**Prepared for: VILLAGE OF HOMER GLEN**  
14933 S. Founders Crossing  
Homer Glen, IL 60491

**EVLYN'S GATE NORTH**  
**SUBDIVISION OBSERVATION REPORT**

**HR GREEN JOB NO. 86120056**

## **Evlyn's Gate North Subdivision Observation Report**

EVLYN'S GATE NORTH  
 DETENTION POND

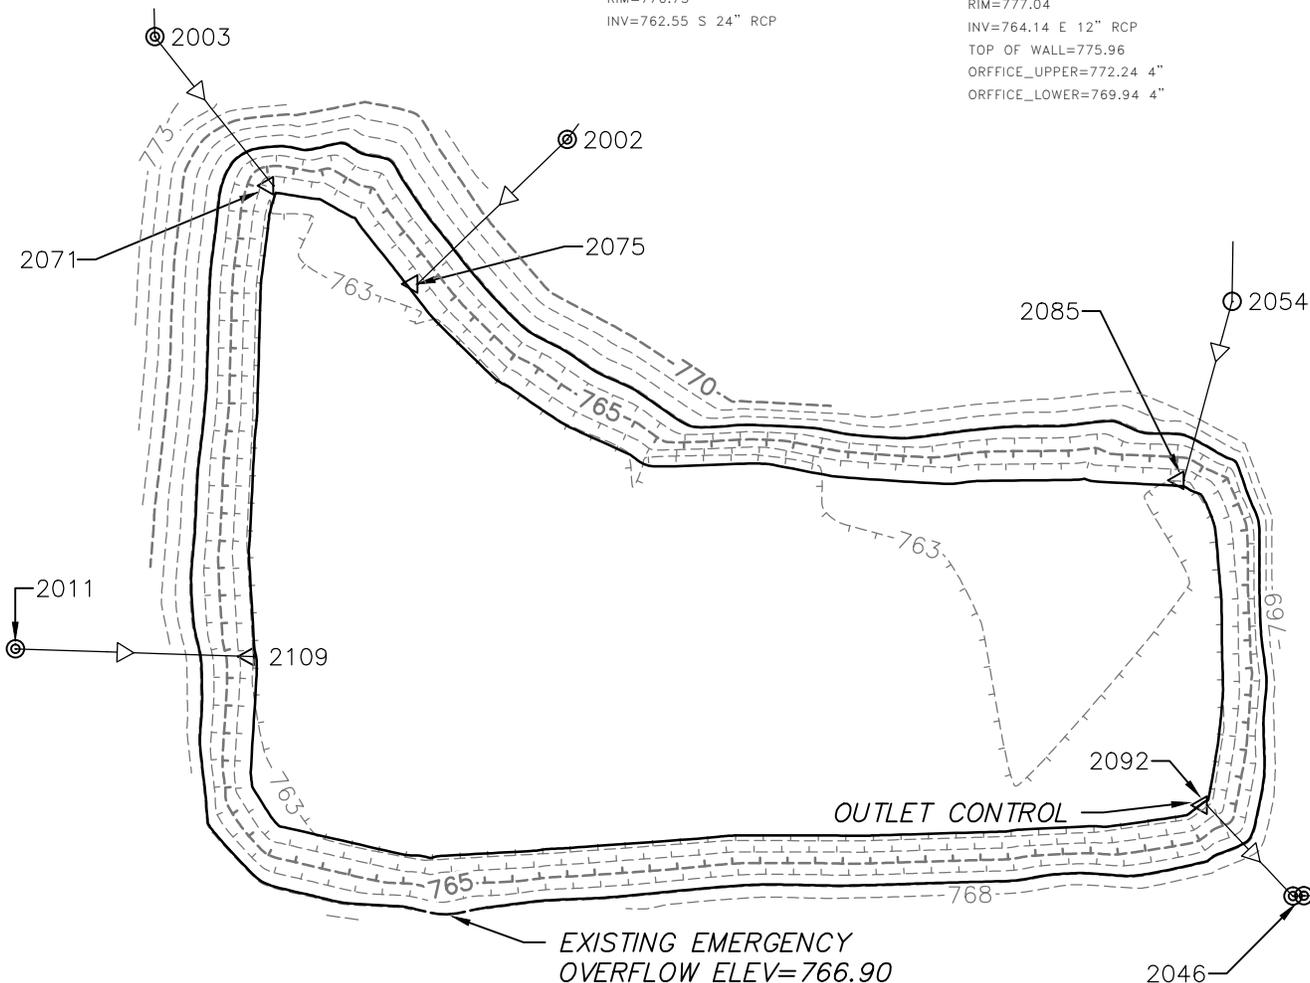
The top of the weir wall was constructed 0.26' lower than proposed. This does not affect the storage capacity of the pond since the emergency overflow weir was constructed 1.2' lower than proposed. This results in a reduced storage volume for the basin. The existing pond has 1.28 ac.ft. less storage volume than proposed. This basin does not comply with the design plans. Our analysis concludes that the existing pond is 18% short of the proposed storage volume. If corrective measures are deemed necessary, adjustments to the overflow weir can be evaluated. A detailed analysis of the original design calculations and existing site conditions would be necessary. HR Green can perform this service at an additional cost.

EXISTING POND VOLUME = 6.01 AC. FT.  
 PROPOSED POND VOLUME = 7.29 AC. FT.  
 REQUIRED POND VOLUME = 7.25 AC. FT.
